Petrotomics Company

Reference: Alternate Concentration Limits Application - Response to open issues 1, 4, and 5
- Source Material License SUA-551

PETROTOMICS TAILINGS FACILITY
APPLICATION FOR ALTERNATE
CONCENTRATION LIMITS
SOURCE MATERIAL LICENSE SUA 551
RESPONSE TO NRC OPEN ISSUES 1, 4, AND 5

RESPONSE TO NRC OPEN ISSUES 1, 4, AND 5

FIGURE 4-6 SCALE 1" = 1500' DATE: OCT. 1997

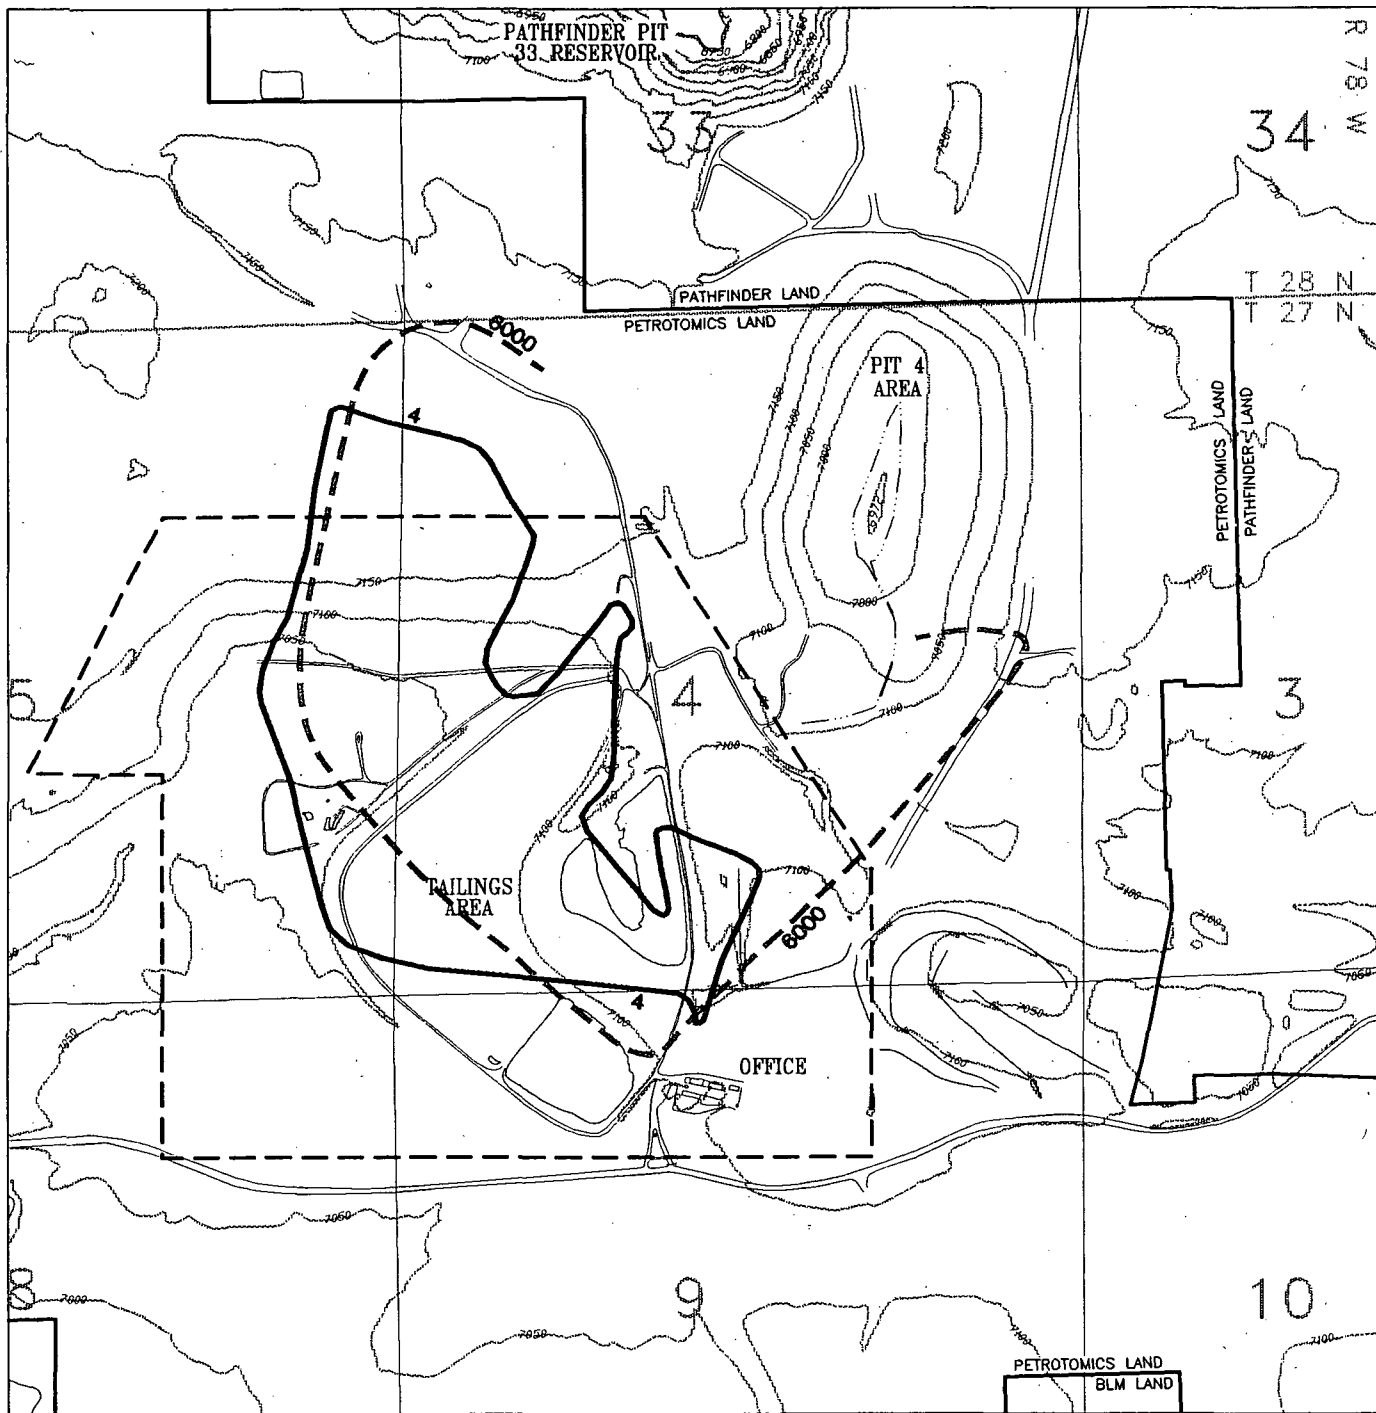
ACTION NEEDED: Petrotomics should address the effects of dispersion and mixing with uncontaminated ground waters with respect to gypsum equilibrium. A fate and transport analysis for sulfate should be provided for the 1,000-year closure period that incorporates gypsum equilibrium, dispersion, and mixing with uncontaminated ground water. Petrotomics is requested to re-examine the pH/sulfate relationship with regard to constituent attenuation using a larger statistical database of well data to verify 1995 trends in constituent concentration, pH, and sulfate.

The pH equal to 4 and sulfate equal to 6,000 mg/L contours for the Upper Sand were plotted for fourth quarter 1990 (Figure 4-5), for 1995 (Figure 4-6), and for first quarter 1997 (Figure 4-7). Fourth quarter 1990 represents the earliest time at which the plumes could be defined, whereas first quarter 1997 represents more recent conditions. It is clear from comparison of Figures 4-5 through 4-7 that sulfate equal to 6,000 mg/L contour has covered a larger area than the pH 4 contour. The changes in the contours between 1990 and 1997 were caused by the corrective action program (Figures 4-5 and 4-7).

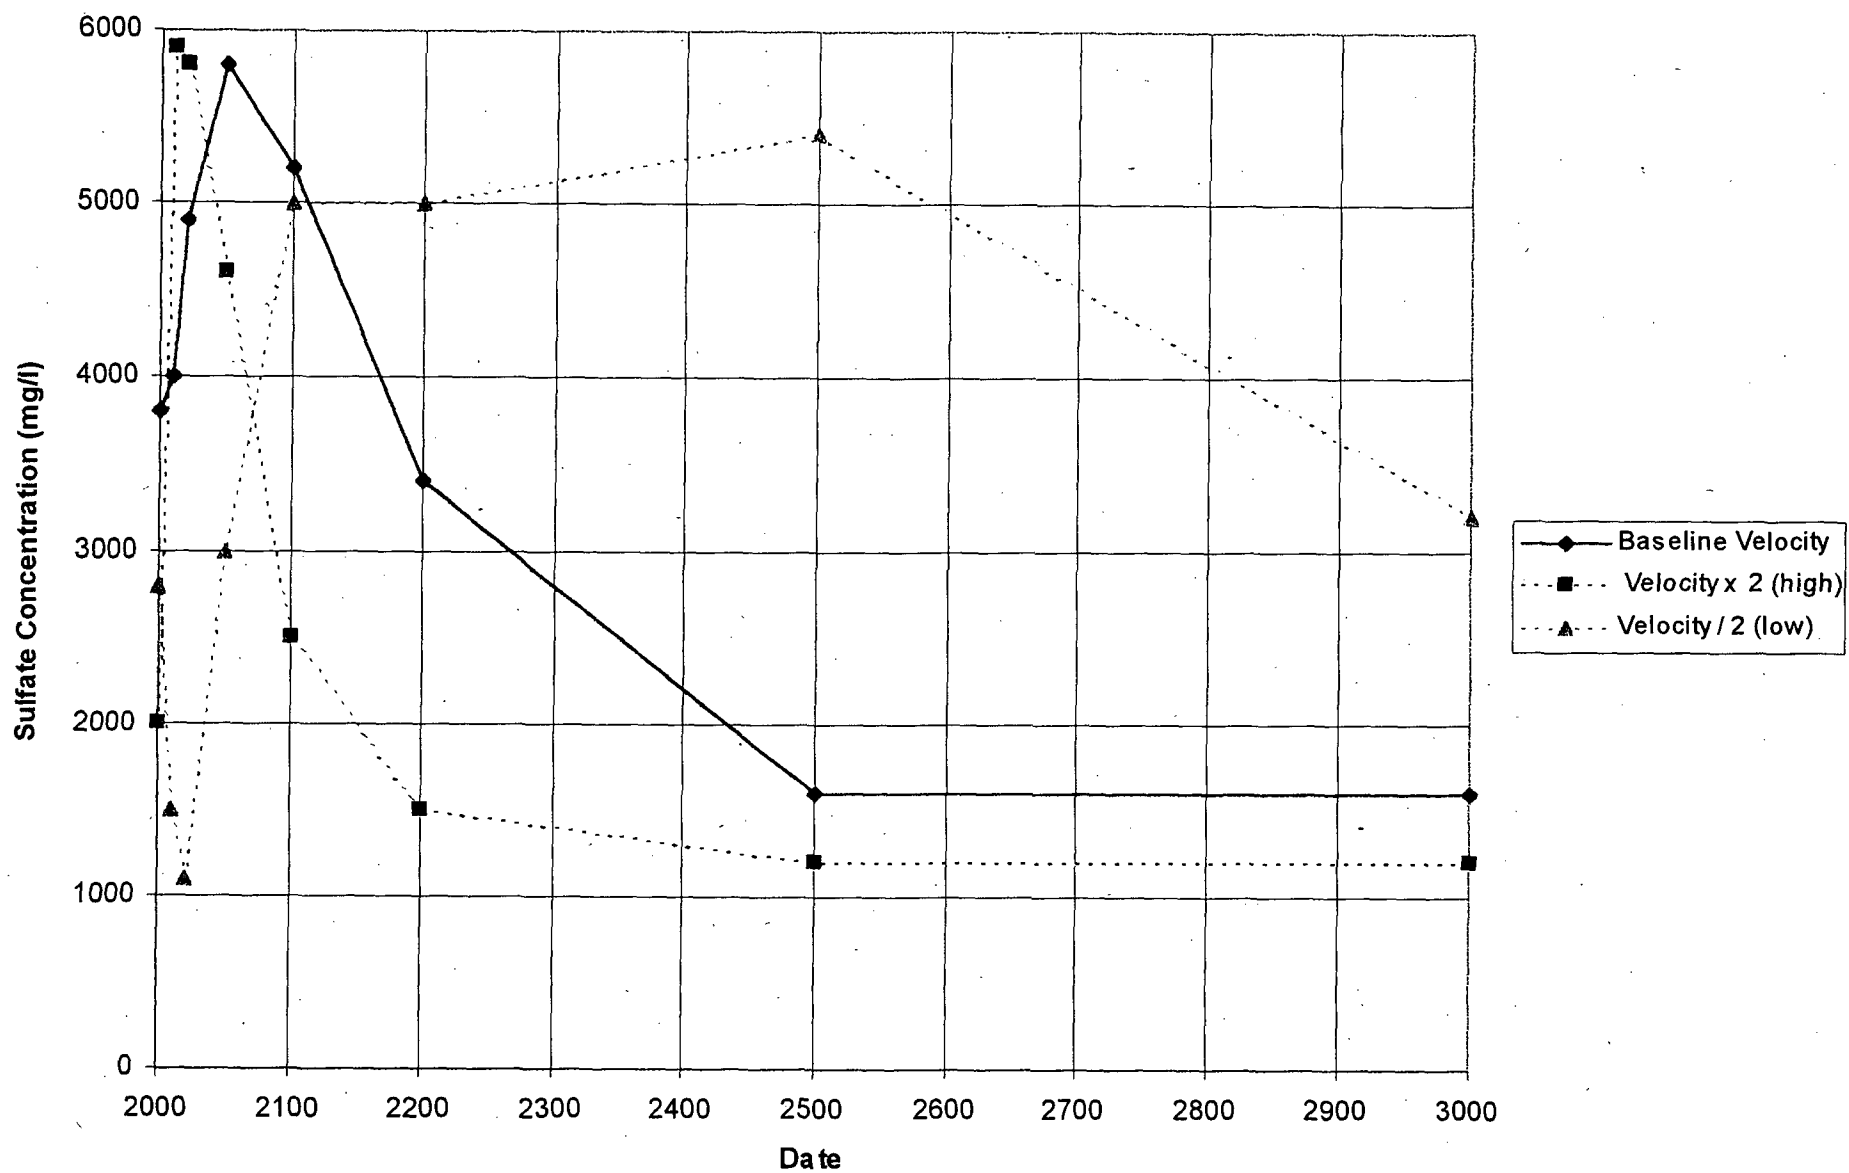
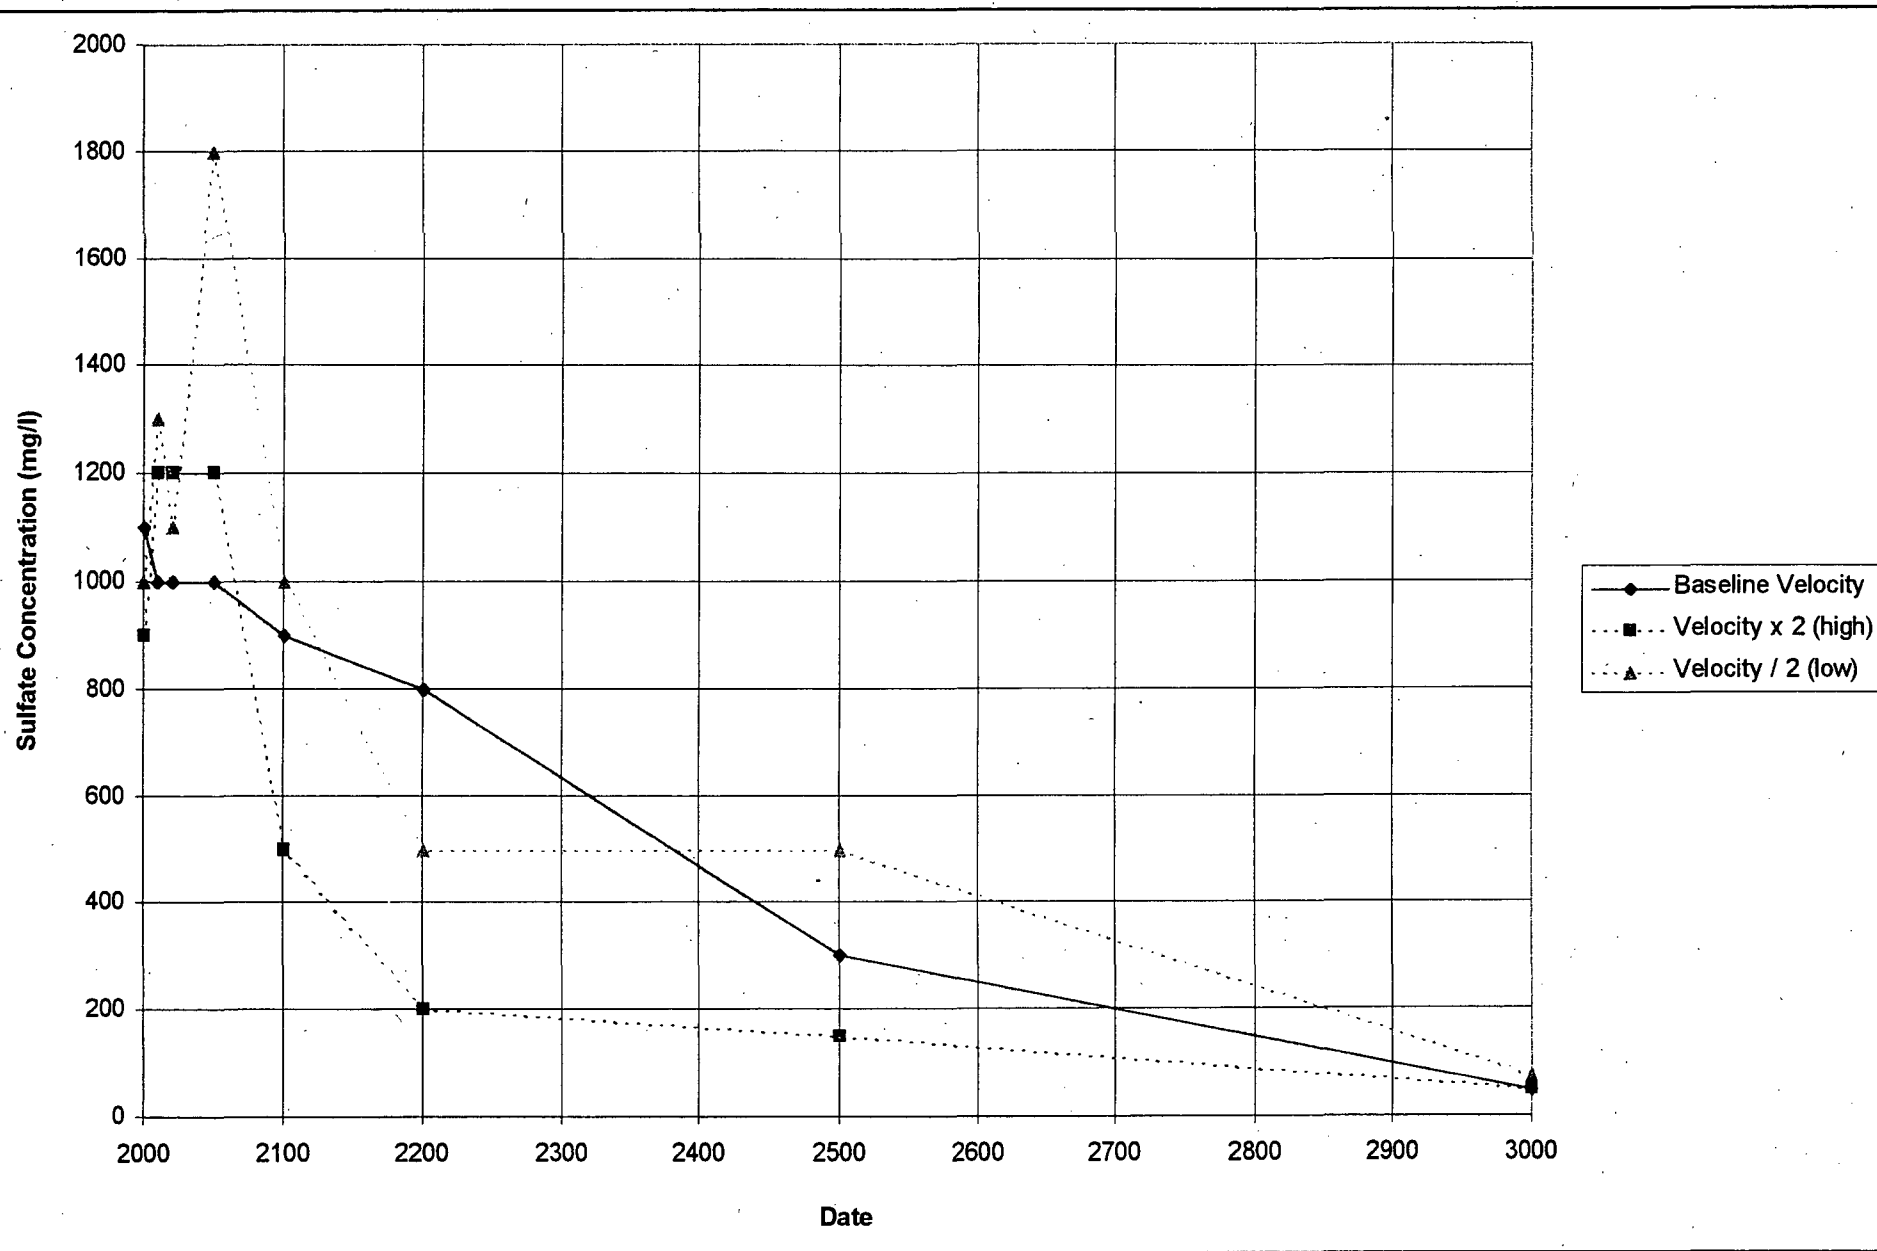
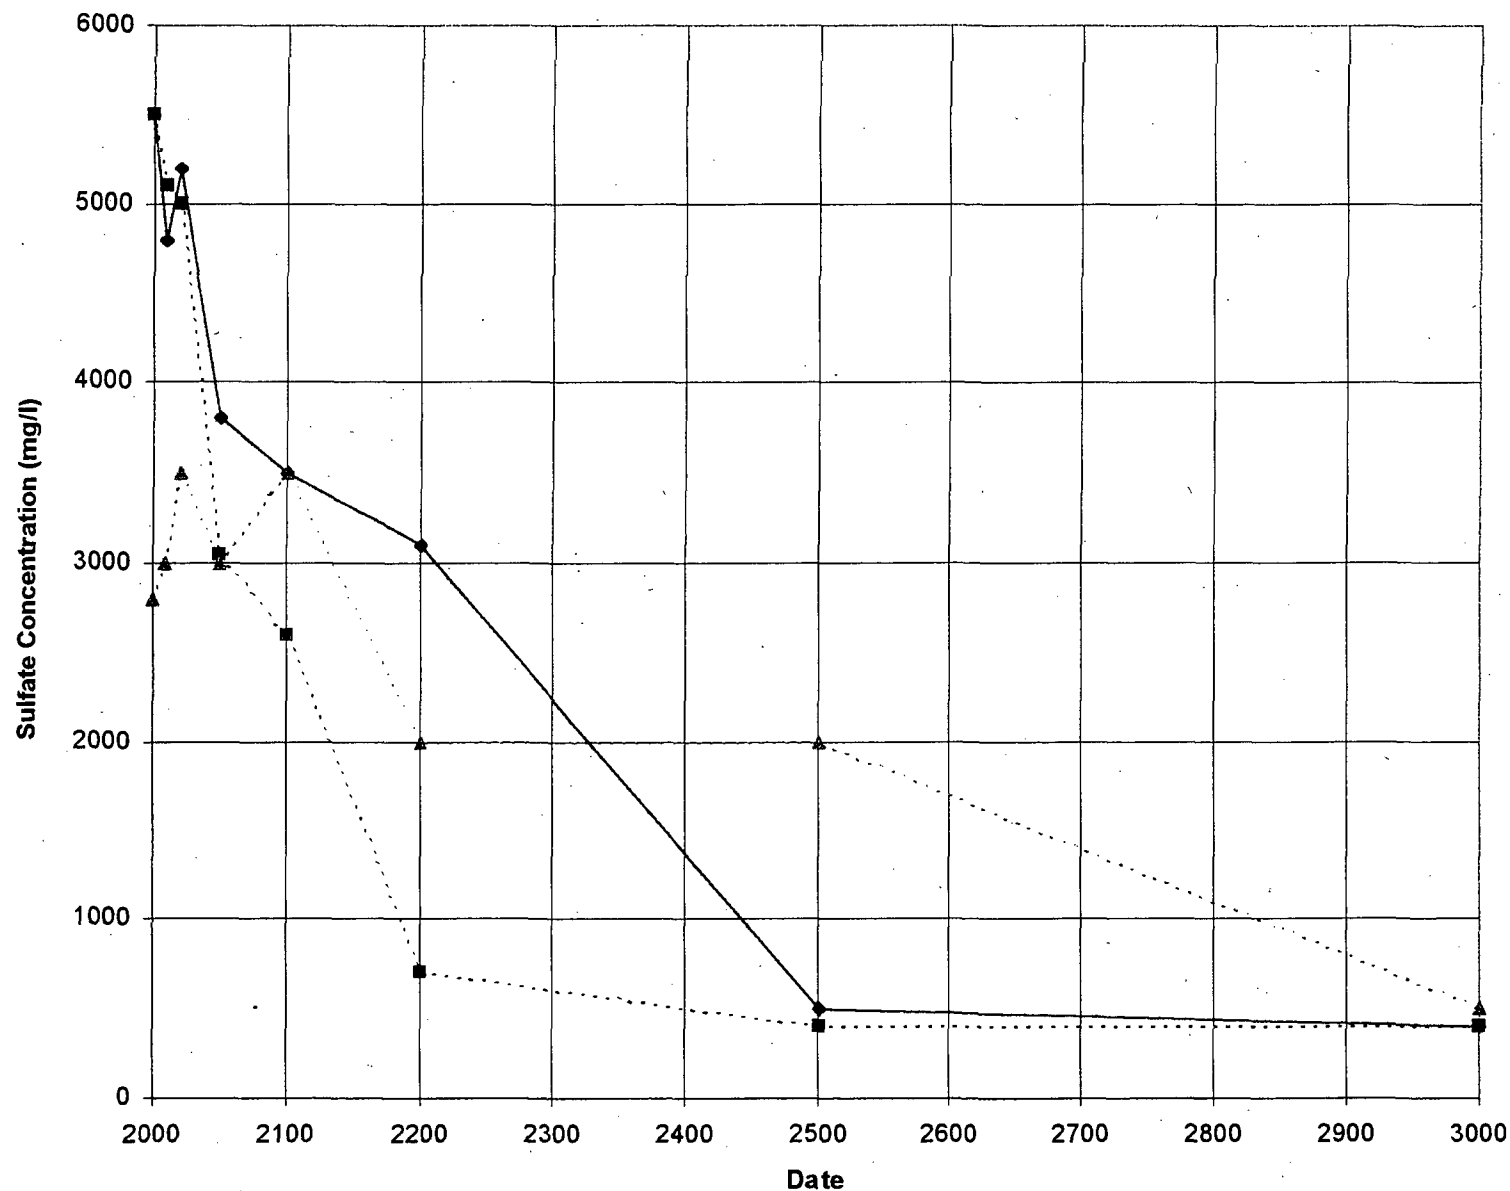
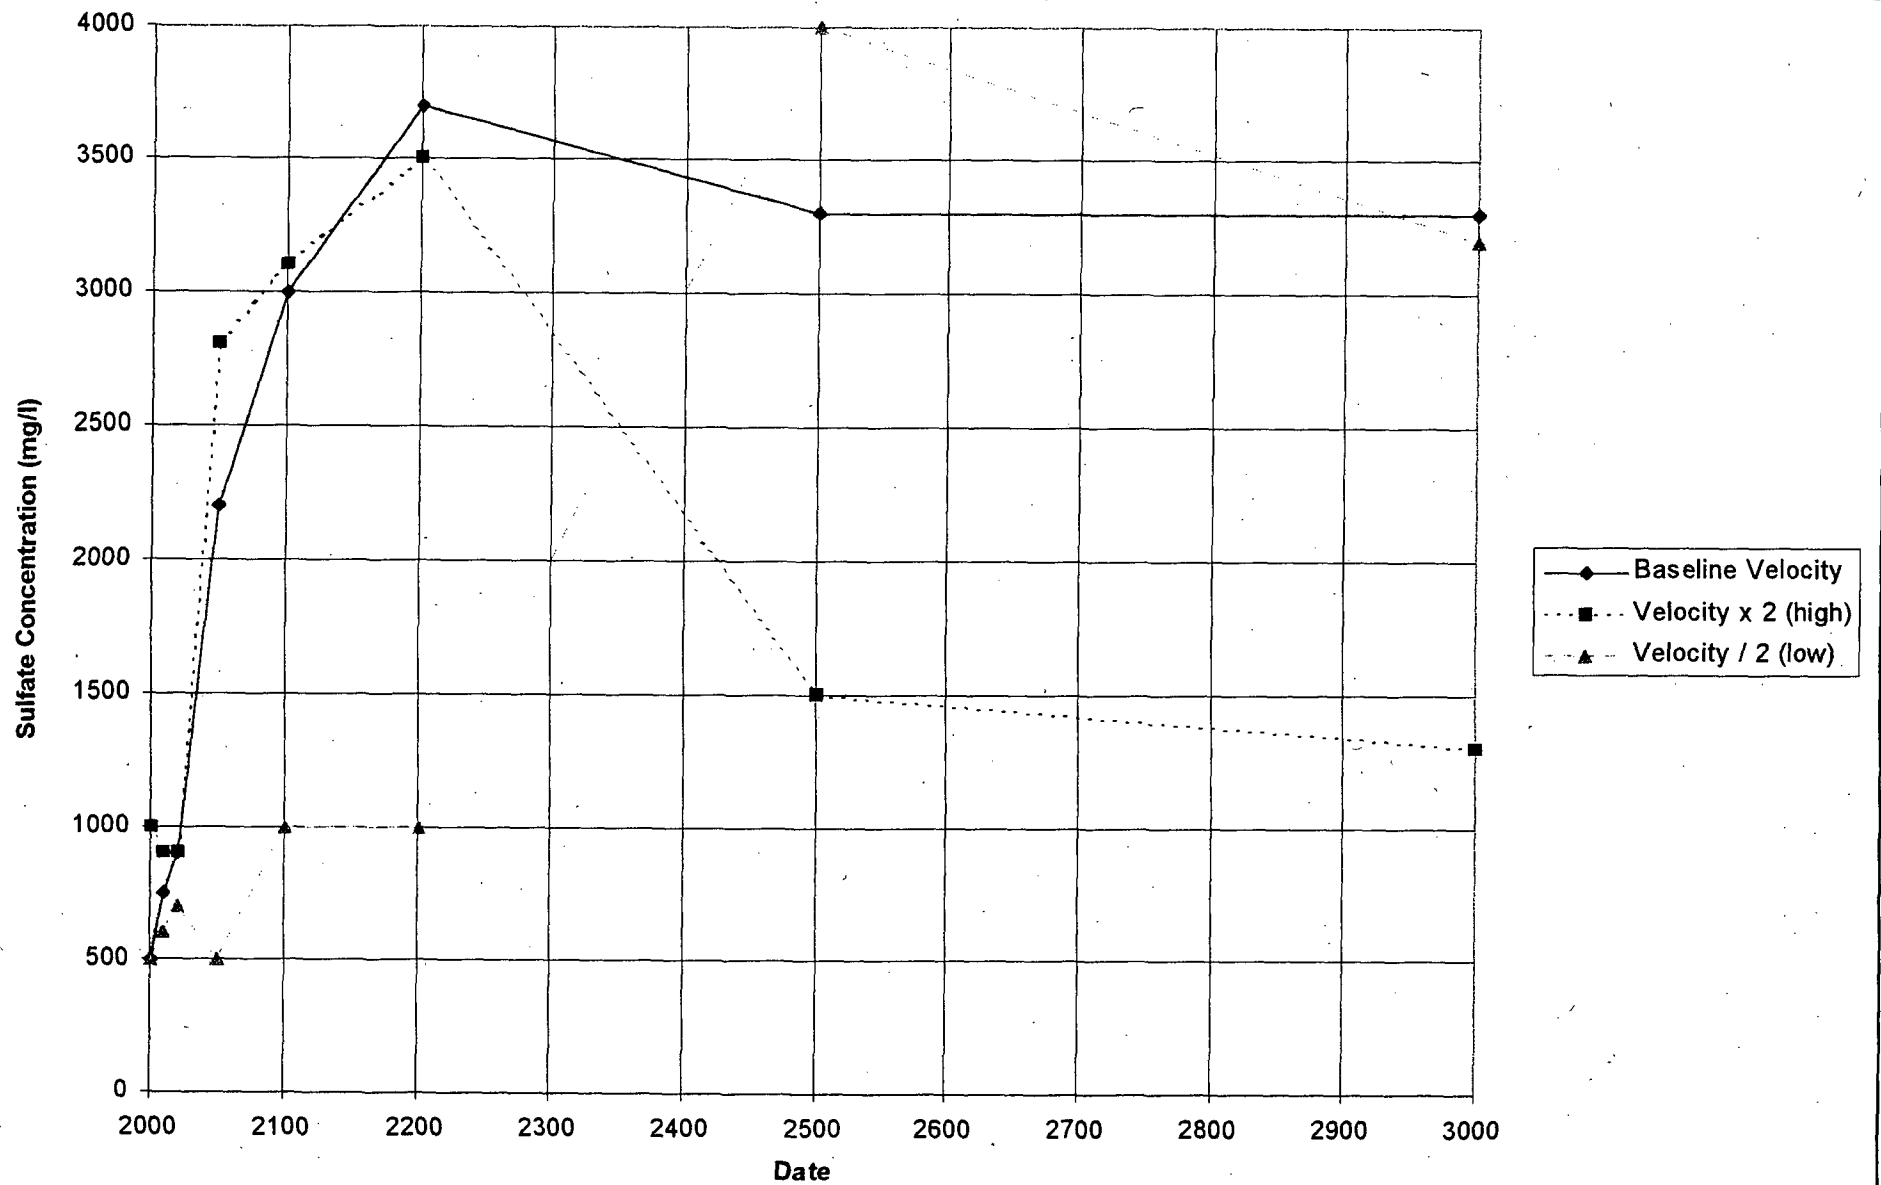
ACTION NEEDED: Petrotomics should provide a quantitative verification that the calibrated model can predict the potentiometric contours of the site in 1996 with reasonable accuracy when initialized in 1985. The conservativeness of the modeling can be proved by showing quantitatively that during the 10-year period of 1986-1996 the model overpredicts the migration of contaminants. If the model predictions are not within the acceptable range, Petrotomics should perform sensitivity analysis to show the conservativeness of the model so that it can be successfully used for conservative predictive modeling for [the] next 1000 [years]. Additionally, Petrotomics should provide a working copy of input files for MODFLOW, basis for hydraulic conductivity values, and its distribution map, and calibrated input parameters.

The sensitivity of model predictions to higher and lower ground water velocity was simulated. The baseline MODFLOW velocity files used by the RAND3D transport model were modified as part of the sensitivity analysis. Baseline velocity files included ground water velocity distributions for the years 1995, 2000, 2010, 2020, 2050, and steady-state. Ground water velocities were adjusted uniformly by a factor of two (100 percent increase in ground water velocity) for the high velocity scenario, and decreased uniformly by a factor of two (50 percent decrease in velocity) for the low velocity scenario. This range of ground water velocity is considered highly conservative, and should adequately account for uncertainties in flow model parameter values. Results of the modified transport model were then compared to the baseline predictions presented in Petrotomics (1996).
